STATE OF WASHINGTON
DEPARTMENT OF ECOLOGY

July 19, 2016

Re: Opinion pursuant to WAC 173-340-515(5) on Proposed Remedial Action for the following Hazardous Waste Site:

- Name: Spic N Span Cleaners
- Address: 652 South Dearborn Street, Seattle, WA
- Facility/Site No.: 54766547
- Cleanup Site ID No.: 3502
- VCP No.: NW2564

NOV-2011	DLG/MS	DATE	SCALE
	000129	SEC		
				SHEET NO 12

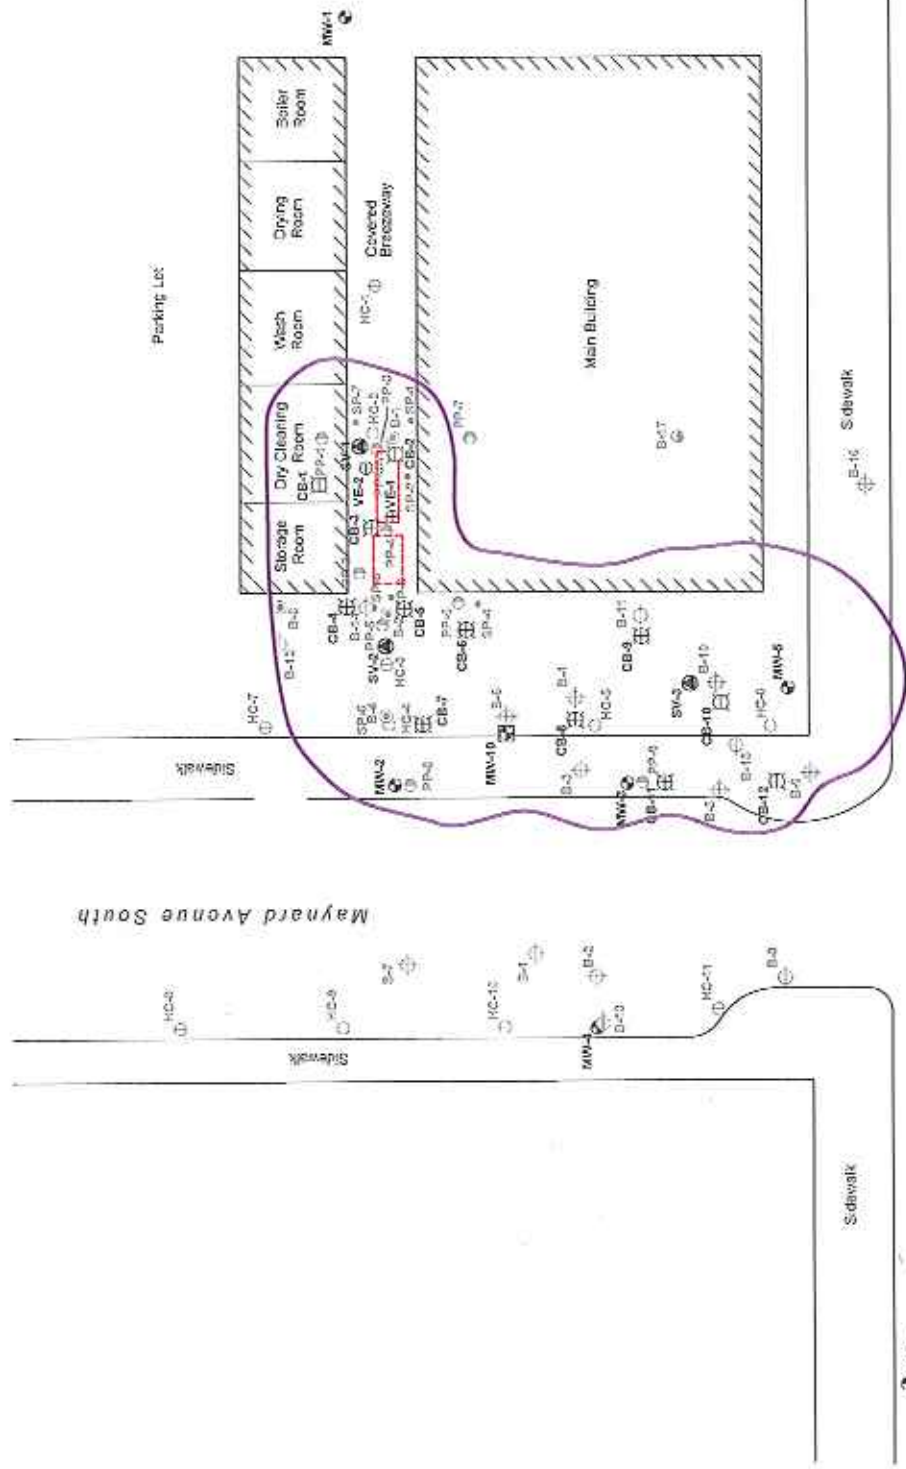
3. In the opinion letter (Document #3), Ecology stated that the compliance monitoring plan included in Document #4 was acceptable. However, since the extent of the contamination was found to be greater than the extent known in 2011, the thermal treatment area has consequently expanded. The treatment area as perceived in 2011 and its current configuration are shown respectively in attached Figure 12 (NOV-2011) and attached Figure 1 (JAN-2016).

ERH Performance Soil Sampling Locations
 Sampling and Analysis Plan
 Spic 'n Span Cleaners Site
 652 South Dearborn Street, Seattle, Washington

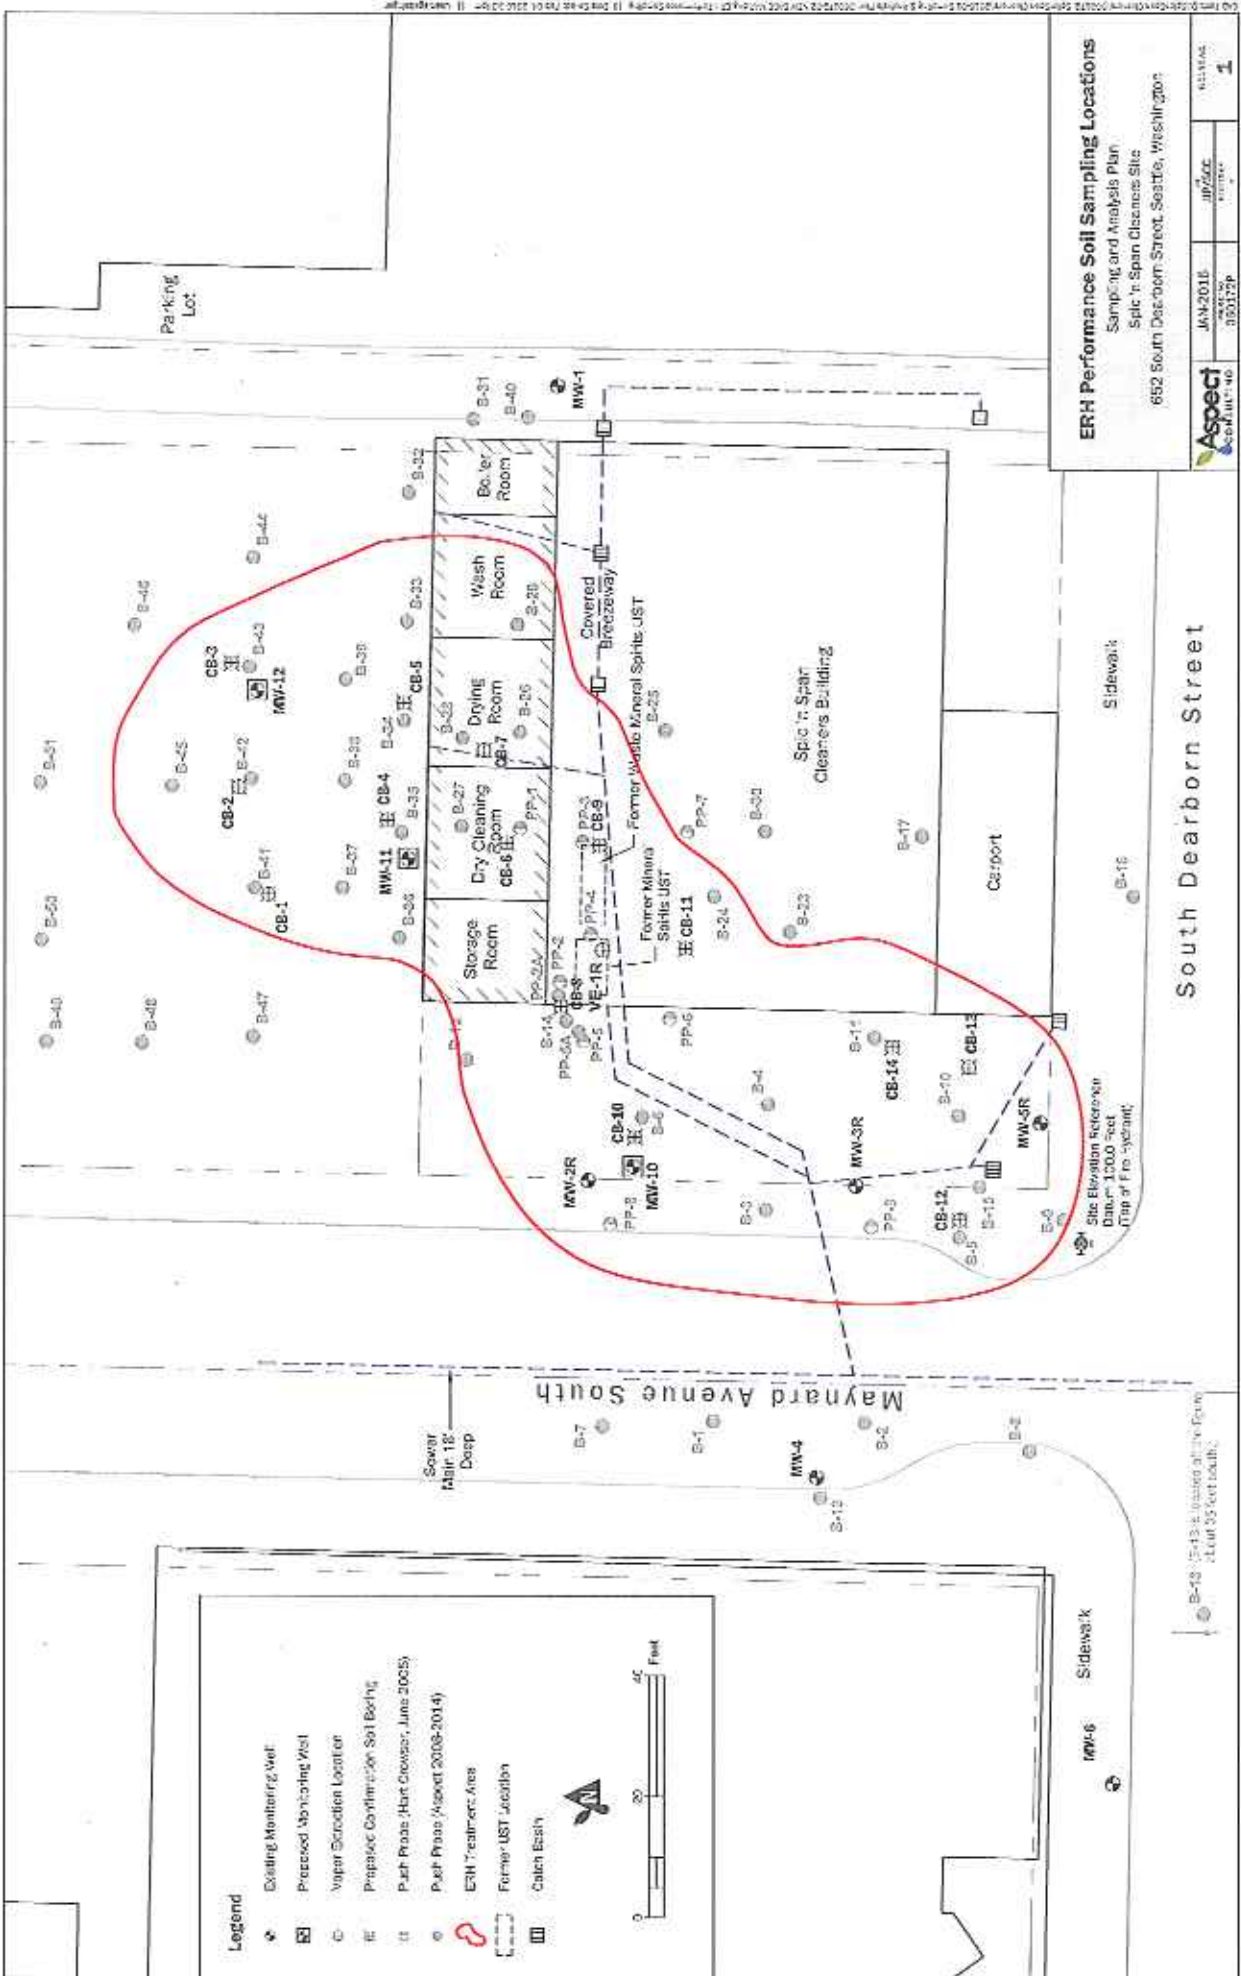
4. After review of the SAP document, Ecology notes that revisions to the original compliance monitoring plan included the following:

- a. The number of soil borings to be sampled at four depth intervals during treatment was increased from 12 to 14.
- b. Boring coverage was reduced in the central part of the treatment area apparently to accommodate increased coverage in the northern expanded portion of the treatment area (ostensibly because of higher soil concentrations there).

- c. The number of ground water monitoring wells to be sampled during treatment in the treatment area was increased from five to seven (two wells were installed in the expanded northern portion of the treatment area). Furthermore, six monitoring wells located outside the treatment area will also be sampled while treatment is in progress. After the thermal treatment stops and the ground cools, quarterly sampling will begin in all 13 monitoring wells at the Site.

- d. The number of soil vapor extraction points to be sampled at this time was increased from three to four to cover the northern area.

It is Ecology's understanding that with these revisions, the sampling procedures outlined in the original compliance monitoring plan remain the same. As described, the revised compliance sampling now provides adequate coverage of the Site, and the sampling procedures are appropriate. Ecology considers that the revised compliance monitoring plan presented in the SAP is acceptable.

PCE Soil Data and Extent of Contamination
 Spec'n Seen Cleaners Svb
 552 South Dearborn Street, Seattle, Washington

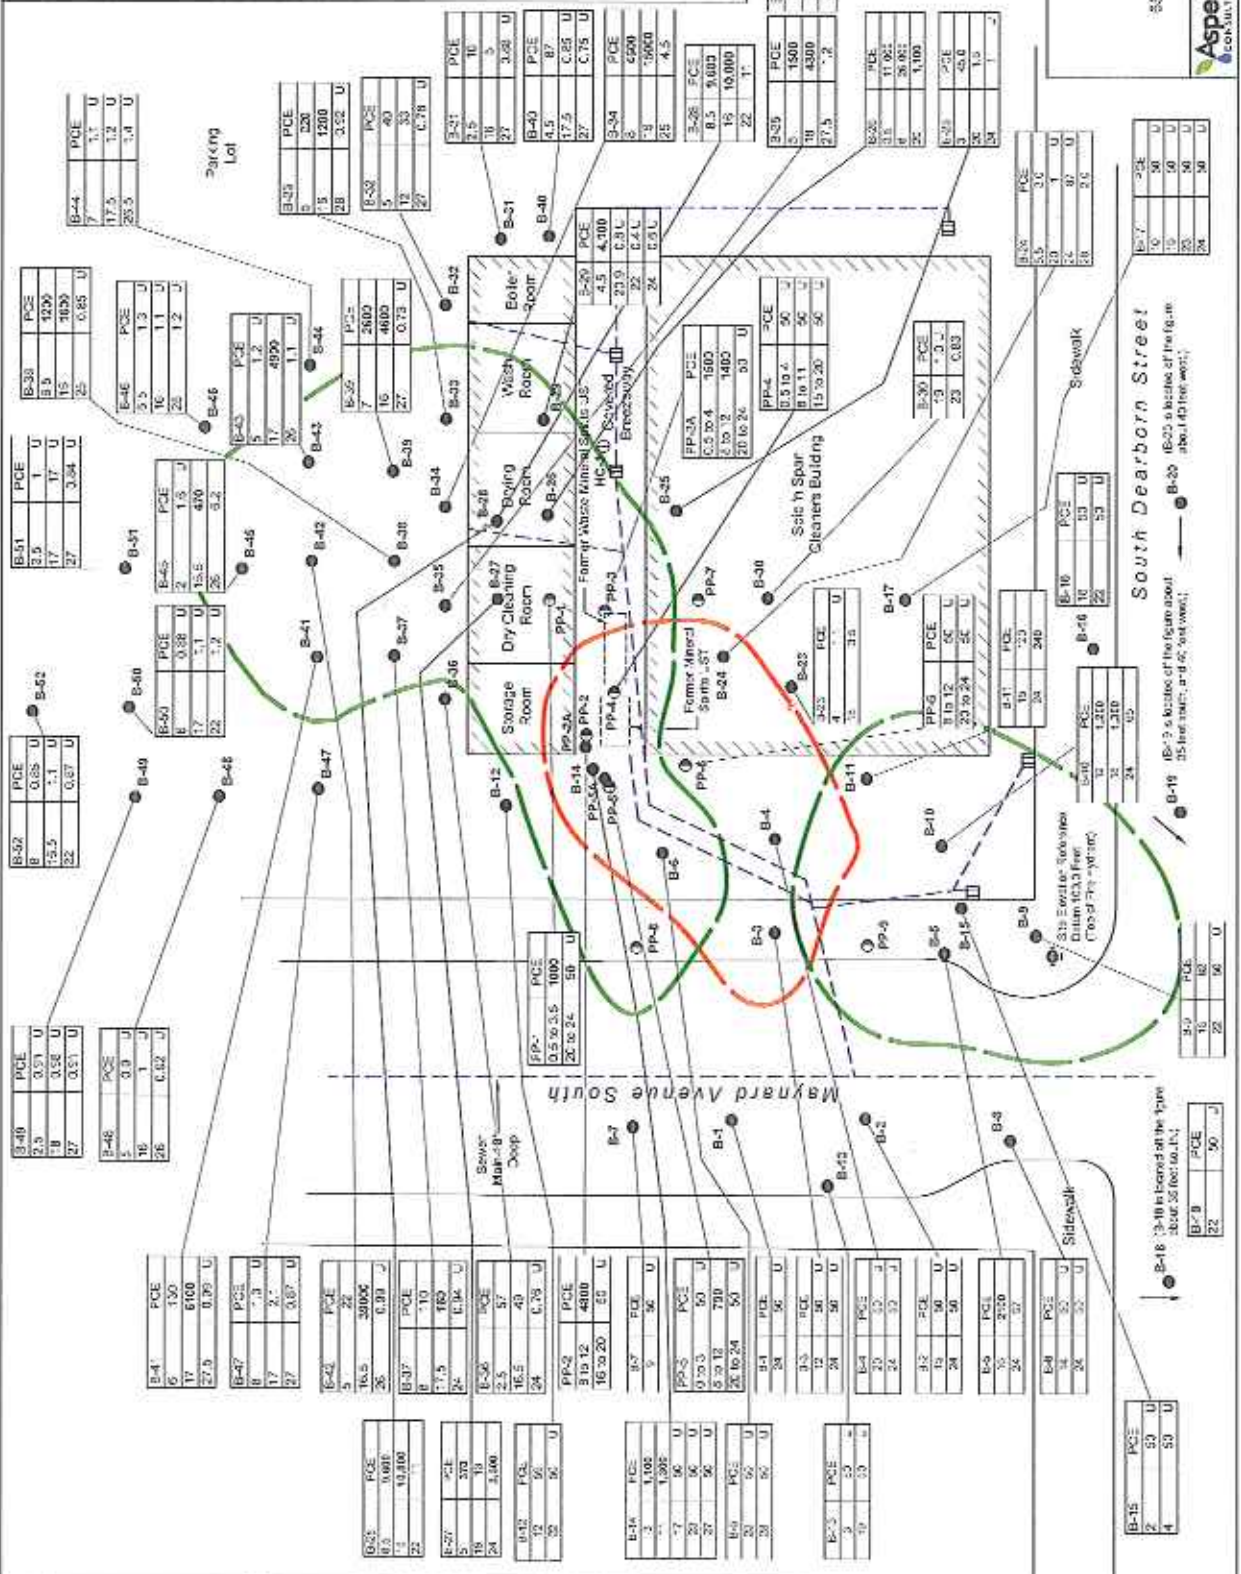
The work determined that the northern area of PCE-contaminated soil previously identified extended further to the north onto adjacent property, and approximately doubled the extent of the soil contamination in that area. Ground water was also found to be contaminated with VOCs in that off-Property area. The area of contaminated soil previously identified that also included TPH contamination, was found to extend further to the southeast beneath the building.

Extent of Soil and Ground Water Contamination: Figure 1 (NOV-2014) depicts the horizontal extent of the soil contamination. The soil contamination (PCE) extends vertically to about 25 feet bgs in the source area. A plume of VC in groundwater extends to the west-southwest nearly 300 feet from the area of soil contamination. The width of the plume is approximately 150 feet.
